**COMMENTS BY THE STATE OF NEVADA  
ON NRC's PROPOSED NEW LICENSING  
STANDARD FOR YUCCA MOUNTAIN**

**December 2005**

**Prepared by the Agency for Nuclear Projects  
Office of the Governor  
1761 E. College Parkway, Suite 118  
Carson City, Nevada 89706  
(775) 687-3744**

**Figure 12-3. Revised Supplemental TSPA One-Million-Year Dose Histories Based on the FEIS Lower-Temperature Operating Mode**

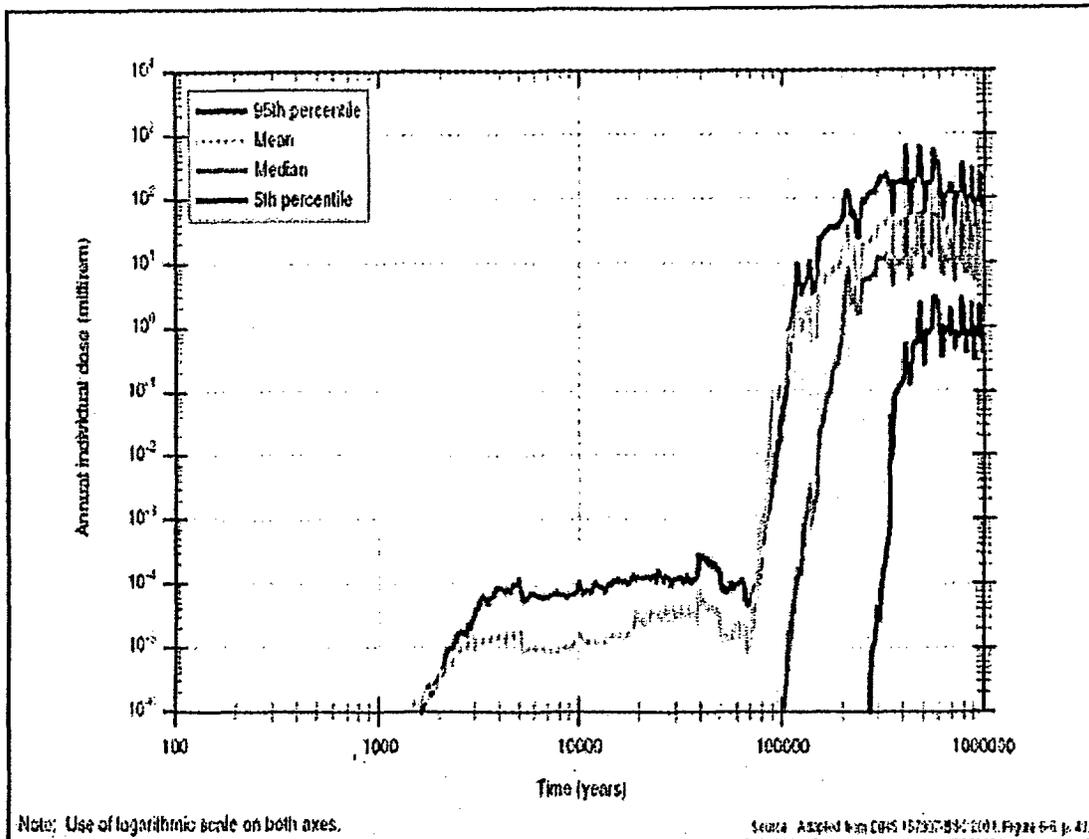
Cohen's Figure 12-3 (DOE's Figure 1-13) below provides an illustration, showing the projected doses from Yucca over a time frame of one million years.

**Figure 1: TSPA-SR One-Million-Year Dose Histories for Nominal Case**  
 (as Figure 12.1 of S Cohen & Associates, 2005, but reproduced from SSPA, Volume 2, Figure 3.1.2-1)

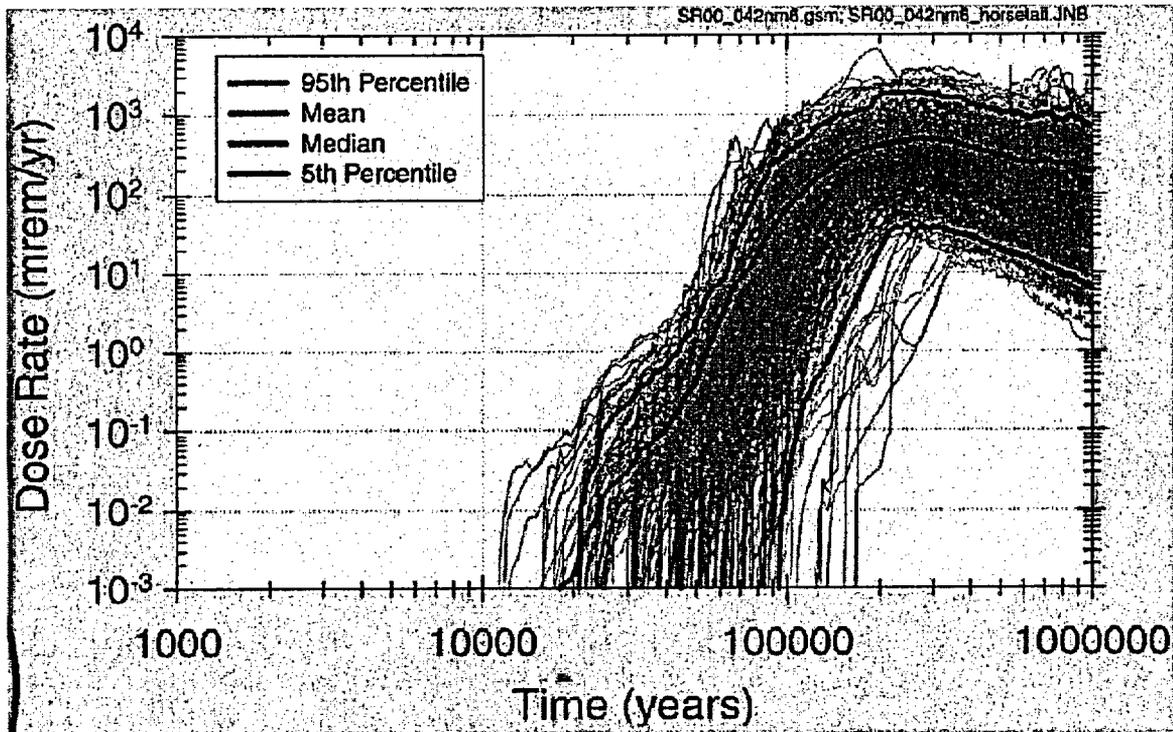
Figure 1 shows various statistical measures of the distribution. These are the arithmetic mean, median, and 5<sup>th</sup> and 95<sup>th</sup> percentiles. Results from the individual realizations are also shown. For the period up to 10,000 years, the EPA is proposing that the arithmetic mean value should be compared with a dose limit of 15 mrem, whereas beyond 10,000 years the EPA is proposing that the median value should be compared with a dose limit of 350 mrem. From Figure 1, it will be seen that the arithmetic mean value exceeds the median value at all times of interest and, in particular, at the time of peak dose. This result is general for any distribution that is positively skewed. The median value at any specific time is obtained by rank-ordering the results obtained from the individual realizations at that time and selecting the value of the mid-ranking result. Thus, if there were 300 realizations, the median would lie between the values of the 150<sup>th</sup> and 151<sup>st</sup> after they had been rank ordered by value. In contrast, the arithmetic mean is defined as the sum of all the results at a particular time divided by the number of realizations.

It should also be noted that if the median was used as a basis for compliance with a constant standard from the time of repository closure onward, an increase in uncertainty with time would not, in itself, necessarily result in greater difficulty in complying with the standard. However, for positively skew distributions, as typically occur in assessment studies, if the median remains constant in time and the uncertainty increases, the arithmetic mean will increase, so compliance with a constant standard will become more difficult with increasing uncertainty. This is illustrated in Figure 2.

**Figure 2: Relationship between the Median and Arithmetic Mean for a Positively Skew Distribution**

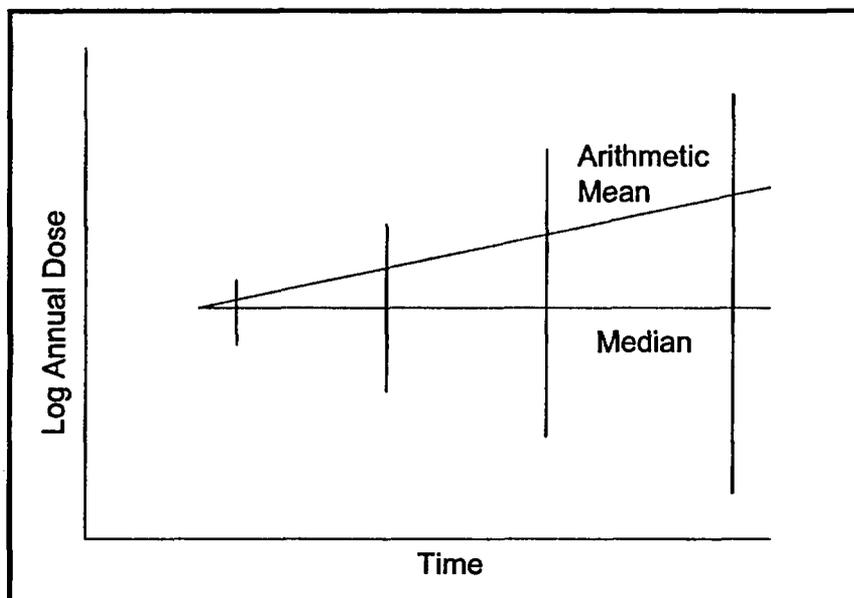
Here a lognormal distribution underlies the range of variation at each time. As time increases, the range of variation increases, but because the range increases both to lower values and to higher values, the median can remain constant (imagine the vertical distance of each value from the median being multiplied by a constant scale factor greater than one as you move from one time to the next). Interestingly, the arithmetic mean value in this system does not remain constant, but increases, because it reflects the magnitudes of the individual values and not just whether they are above or below the median value. This distinction is general for positively skew distributions and can be quantified for particular examples. Thus, for the example of the commonly used lognormal distribution:

On this basis, the use of the median as a compliance measure diminishes the importance of changes in uncertainty with time relative to use of the arithmetic mean. However, it is not accepted that the uncertainty in performance at Yucca Mountain does increase substantially with time. This is demonstrated by a careful consideration of Figure 1. Both the median and 95<sup>th</sup> percentile can be seen at 50,000 years, where they differ by three orders of magnitude. At the peak, around 200,000 years, they differ by only one order of magnitude and this difference persists through to the end of the simulation.

**Figure 3: Figure 3.2.2-12 from Volume 2 of the SSPA, illustrating a Case with the Base Case Seepage Model and Neutralized Waste Packages and Drip Shields**

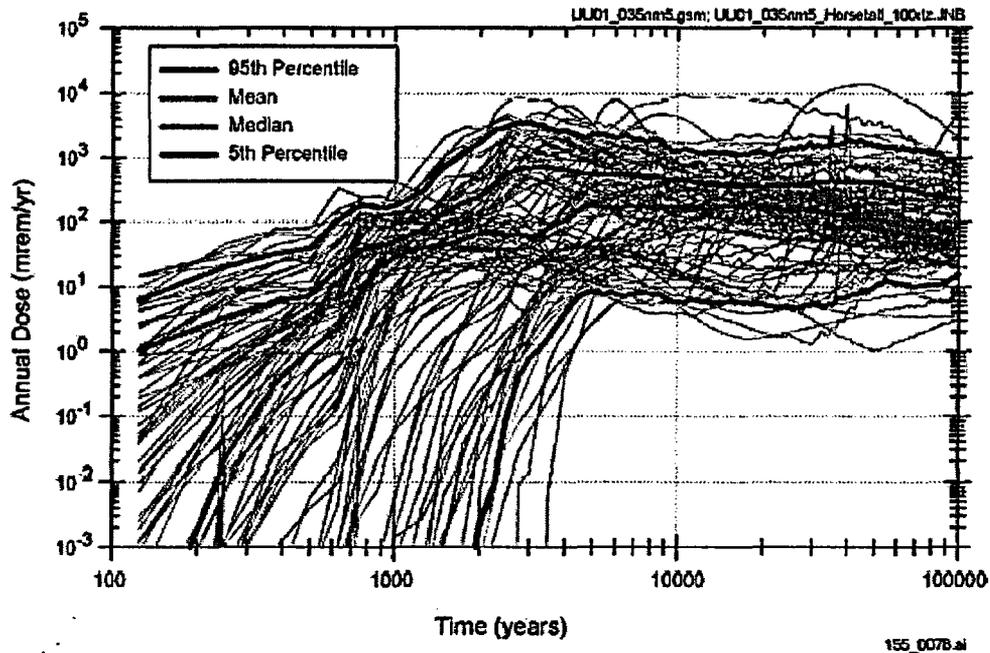
Note that, in this case, the uncertainty decreases until it reaches a fairly constant value from approximately 4,000 years onward.

However, care should be exercised in interpreting this type of presentation. This is because the figures confound uncertainty in timing with uncertainty in the magnitude of the peak dose that arises. This is illustrated schematically in Figure 4.

**Figure 5: Figure 3.2.5.4-1 from Volume 2 of the SSPA, illustrating the Sensitivity of Annual Dose to Additional Uncertainty associated with Early Waste Package Failures due to Improper Heat Treatment**

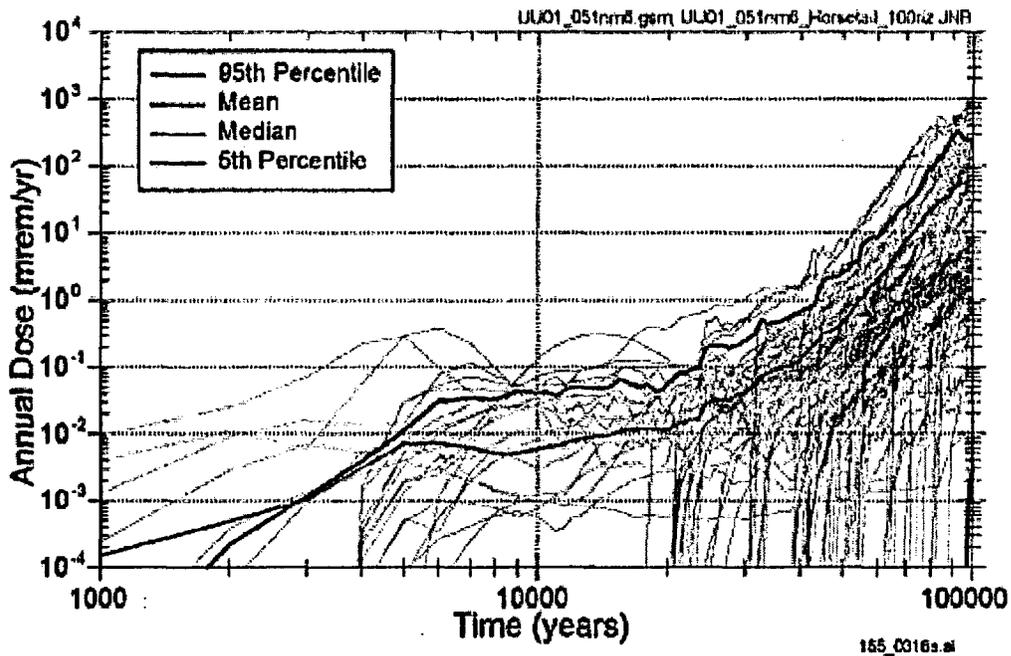
In Figure 5, the uncertainty to 40,000 years is very large (note that the median does not appear on the figure and the mean is higher than the 95<sup>th</sup> percentile over the first 2,500 years. Beyond 40,000 years there is a transition from a system dominated by releases from the waste packages that failed early to a system dominated by more general waste package failure. Beyond that time, as it becomes increasingly likely that the majority of the packages have failed, the uncertainty range decreases and, by 100,000 years, the difference between the median and the 95<sup>th</sup> percentile is only about a factor of twenty.

It should also be noted that 10,000 years does not represent a time at which there is necessarily a qualitative change in system performance. Thus, in Figure 1, the qualitative change occurs beyond 20,000 years. In Figure 3, there is no qualitative change and system performance remains much the same from 2,000 to 100,000 years. In Figure 5, the qualitative change occurs beyond 20,000 years, when early package failure becomes dominated by more general package failure.

**Figure 6: Figure 3.2.1-1 from Volume 2 of the SSPA, illustrating Annual Dose Histories from the Extended Climate Model and the Base Case**

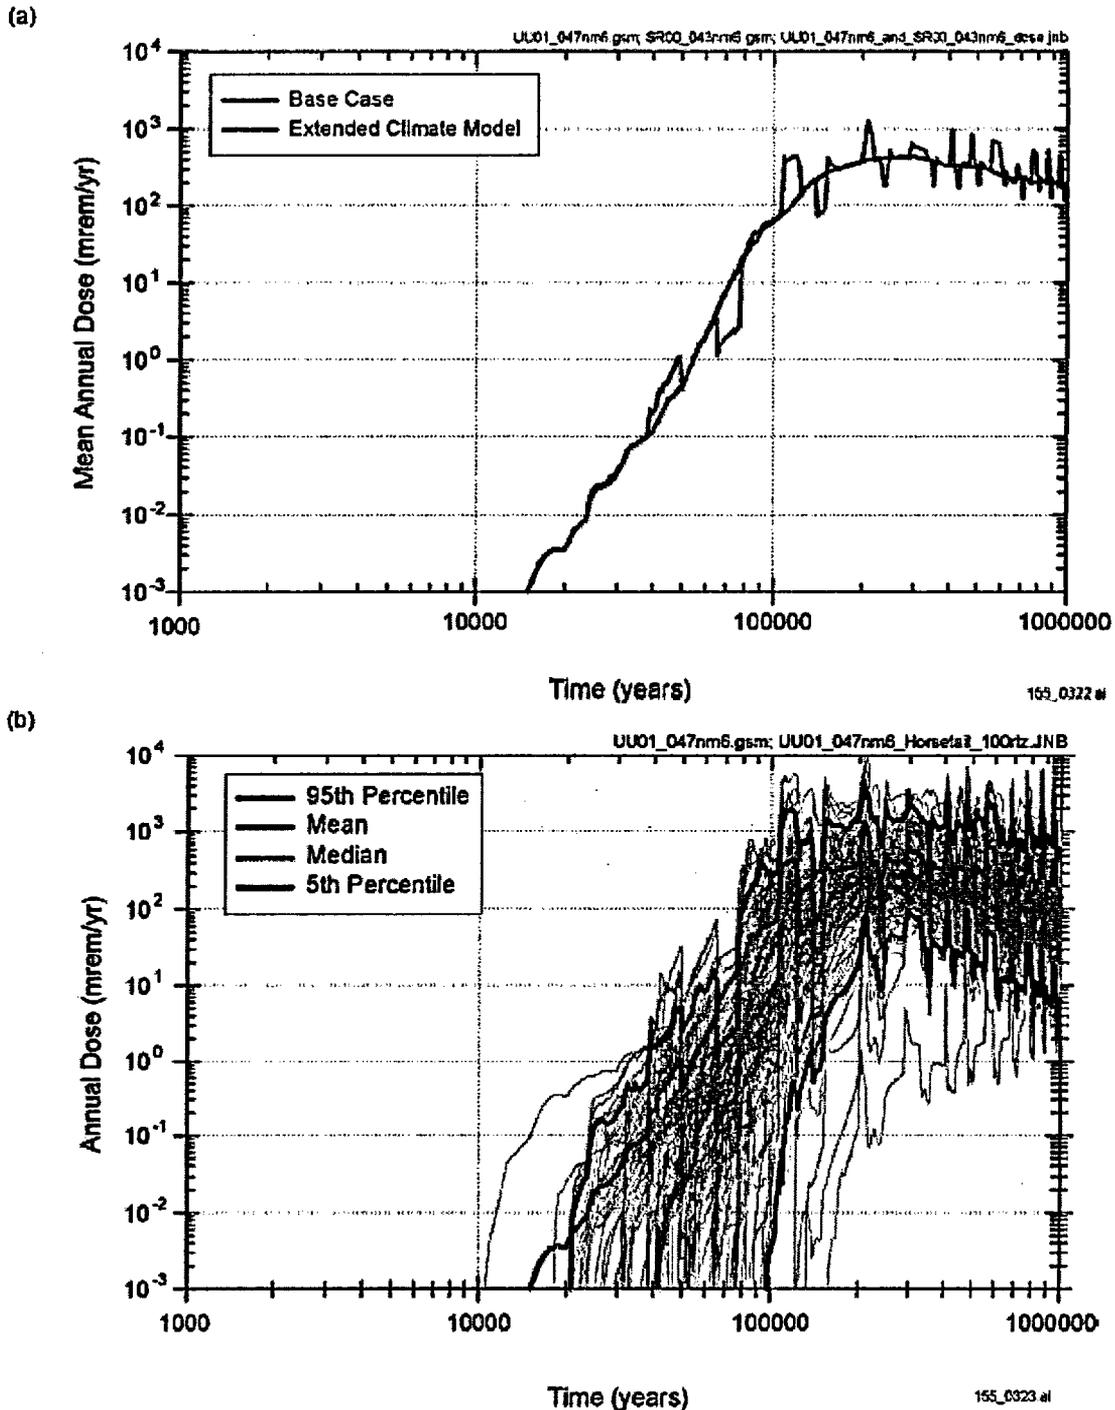
A further consideration in respect to uncertainty is shown in Figure 6.

for the period from 10,000 years to one million years was also developed. In this model, six climate states were determined for the post-10,000 year period. The extended base-case climate model is the same as the base-case climate model until 38,000 years, i.e. there is no change in climate state from 2,000 years to 38,000 years, which is when the first glacial period is estimated to occur. The next glacial periods occurs at 106,000 years and 200,000 years. Glacial periods are 8,000 to 40,000 years in duration and recur approximately every 90,000 years, on average. Figure 6, part a compares the mean data from the base case run to one million years, i.e. with no climate change beyond 2,000 years, and the extended climate model. Comparison of these mean curves when long-term climate change is taken into account reveals increased uncertainty, reflected in the more variable nature of the mean annual dose in the extended climate model case. However, Figure 6, part b shows that this is not the full story. The spikiness arises because the changes of climate are represented as discrete switches between one climate state and another at pre-defined, identical times in all realizations. In practice, climate changes continuously. Furthermore, even if the process is simplified in terms of instantaneous switches, e.g. by arbitrarily defining boundaries between the states in terms of mean annual precipitation, the timing of those changes is uncertain and should not be the same in every realization. Both of these considerations would smooth the dose curve from that shown for the extended climate model case. Thus, the increased uncertainty that might be inferred from Figure 6 is an artifact of the modeling procedure used and does not relate to the actual system being simulated.
